National Beyond visual line of sight Experimentation Corridor
Airspace Change Proposal

Targeted Engagement report

Engagement report – Cranfield NBEC ACP

2.1 Updated proposed NBEC route

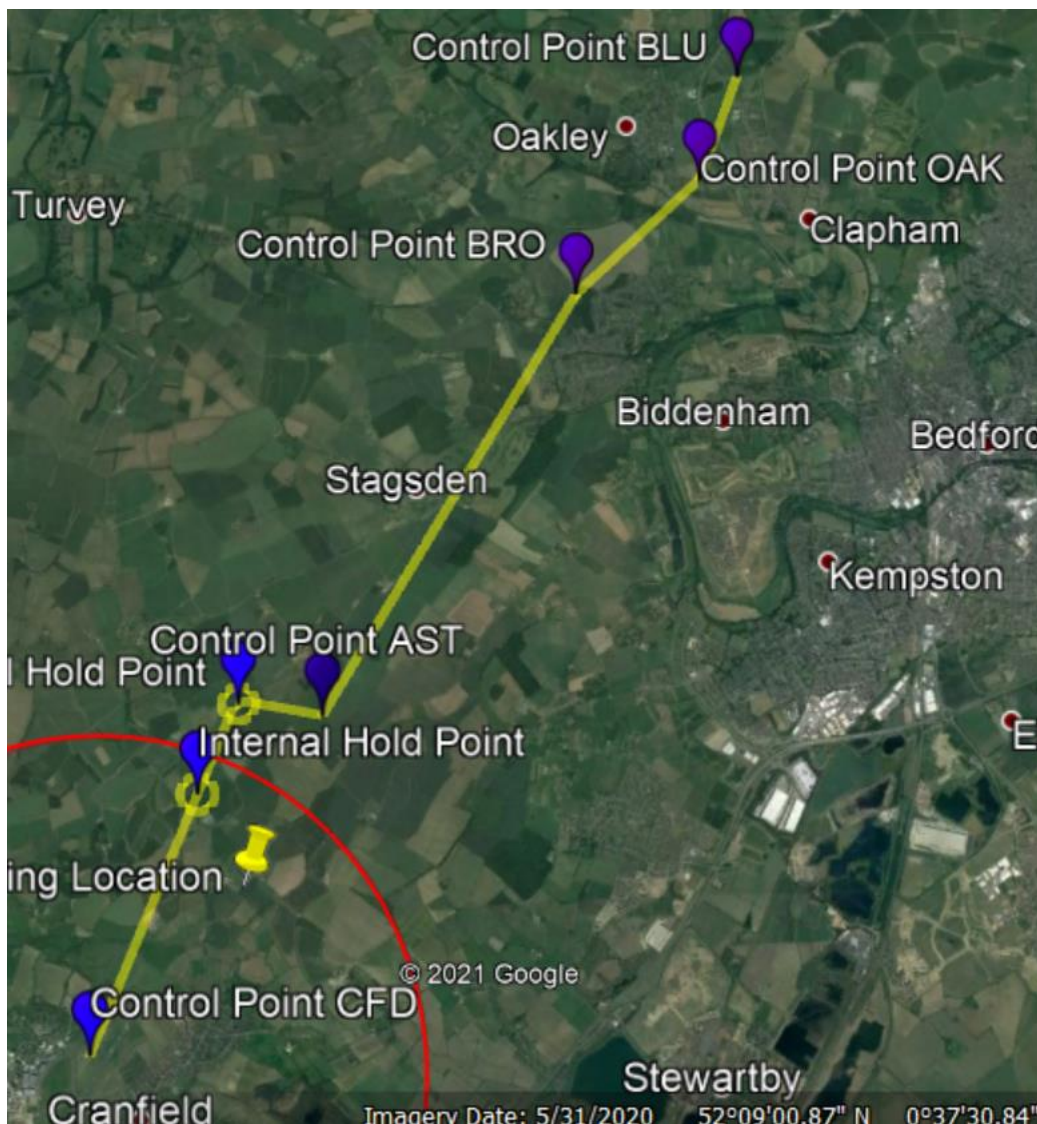
A further review of the route considering avoidance of villages was also conducted.

The image below shows the proposed NBEC flight path routing which has been reviewed and updated slightly in order to minimise overflight of residential areas, and to be coherent with operational procedures developed with Cranfield ATC:

- The airspace will be activated by NOTAM.
- NOTAMs will include contact details including Cranfield ATCs telephone number and frequency.
- NOTAMs will be published at least 48 hours in advance.
- Cranfield ATC will provide a DACS as described in Appendix E.
- UAV flight path routing has been adjusted to minimise residential overflight.
